Technical Service Bulletin (TSB)
Umbrella Valve Seal Missing From Cylinder Head Cover

REFERENCE:	TSB: 09-017-26 REV. A GROUP: 09 - Engine	Date:	August 19, 2026	REVISION:	09-017-26
VEHICLES AFFECTED:	2026 - 2027 (WL) Jeep Grand Cherokee / Grand Cherokee L This bulletin applies to vehicles built on or before August 15, 2026 (MDH 0815XX) equipped with a 2.0L Hurricane 4 Turbo W/ESS (Sales Code EC7).			MARKET APPLICABILITY: ☒ NA☐ MEA ☐ EE☐ IAP ☐ SA☐ CH NOTE: This bulletin applies to North America markets.	
CUSTOMER SYMPTOM:	Customer may experience a MIL-ON and/or an indication of low engine oil level. Upon inspection the technician may find the following: 1. One or more of the following Diagnostic Trouble Codes (DTCs) have set: - P0300-00 - Random/Multiple Cylinder Misfire Detected. - P0301-00 - Cylinder 1 Misfire. - P0302-00 - Cylinder 2 Misfire. - P0303-00 - Cylinder 3 Misfire. - P0304-00 - Cylinder 4 Misfire. 2. Engine oil level is low. IMPORTANT! If none of above symptoms are present, this TSB does NOT apply.

CAUSE:	Cover Cylinder Head Umbrella valve seal missing

Fig. 1
Oil Level Inspection

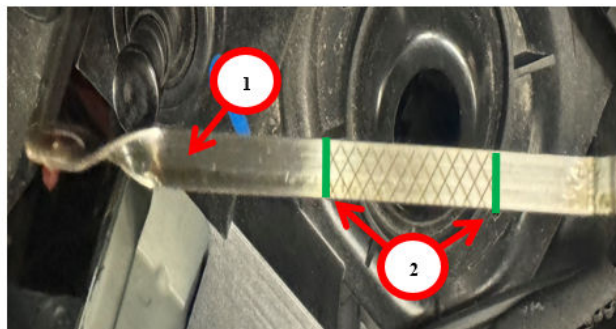
1. Inspect the engine oil level [Fig. 1](#).

2. Is the oil level low [Fig. 1](#)?
 - YES>>> Proceed to [Step 3](#).
 - NO>>> This bulletin has been completed. Use Inspection LOP 09-35-20-98) to close the active RSU.
Refer to service library for further misfire diagnosis.

Fig. 2
PCV Valve During Removal

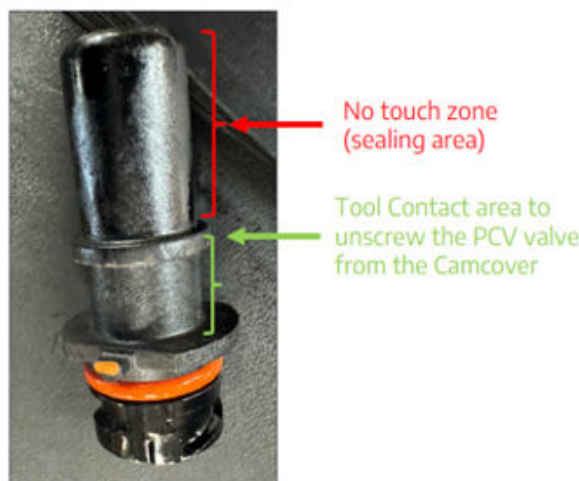
NOTE: Be sure to follow warnings regarding location on the PCV valve where tool contact should be avoided [Fig. 2](#).

Fig. 3
Approved Zone - PCV Valve Removal

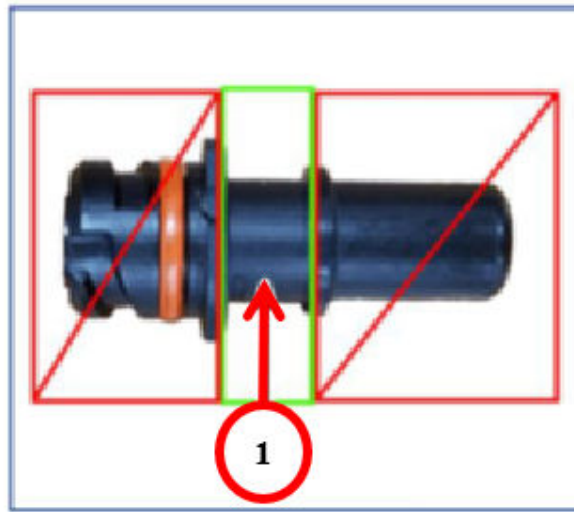
NOTE: Use a pair of thin nosed pliers inserted into the approved zone on the PCV valve for removal [Fig. 3](#).

Fig. 4
Borescope to PCV Valve Opening

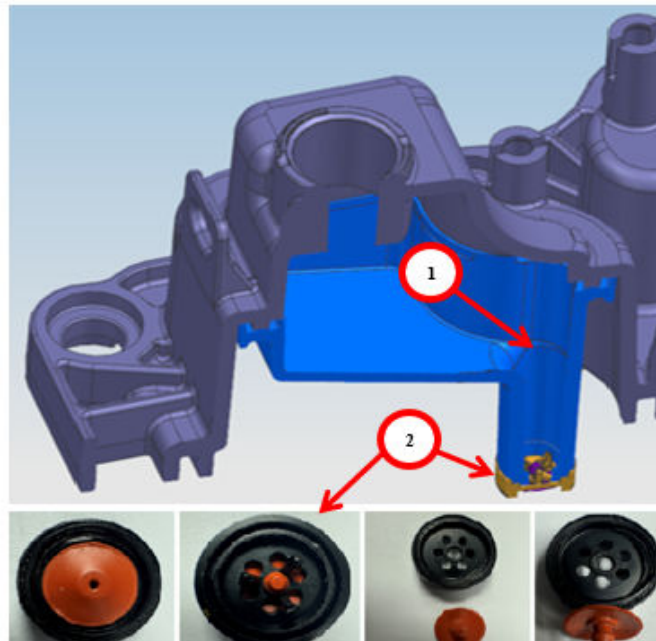
4. With the PCV valve removed, insert a borescope into the PCV valve opening [Fig. 4](#) to inspect if the umbrella valve is missing or present [Fig. 5](#) [Fig. 6](#).

5. Is the umbrella valve seal missing [Fig. 5](#)?
 - YES>>> Replace the cylinder head cover assembly. Refer to the detailed service procedures available in DealerCONNECT/Service Library under: Service Info> 09 - Engine, 2.0L / Cylinder Head / Cover(s), Cylinder Head / Removal and Installation and then proceed to [Step 6](#).
 - NO>>> This bulletin has been completed. Use Inspection LOP (09-35-20-98) to close the active RSU.
Perform further oil consumption diagnosis as required.
6. Ensure that the engine oil level is to proper specification.
7. **Using wiTECH, perform the PCM Reset ECU routine. Navigate to **Guided Diagnostics > Reset ECU**, select **PCM**, and follow the on-screen instructions to complete the procedure.**
8. Clear DTCs.
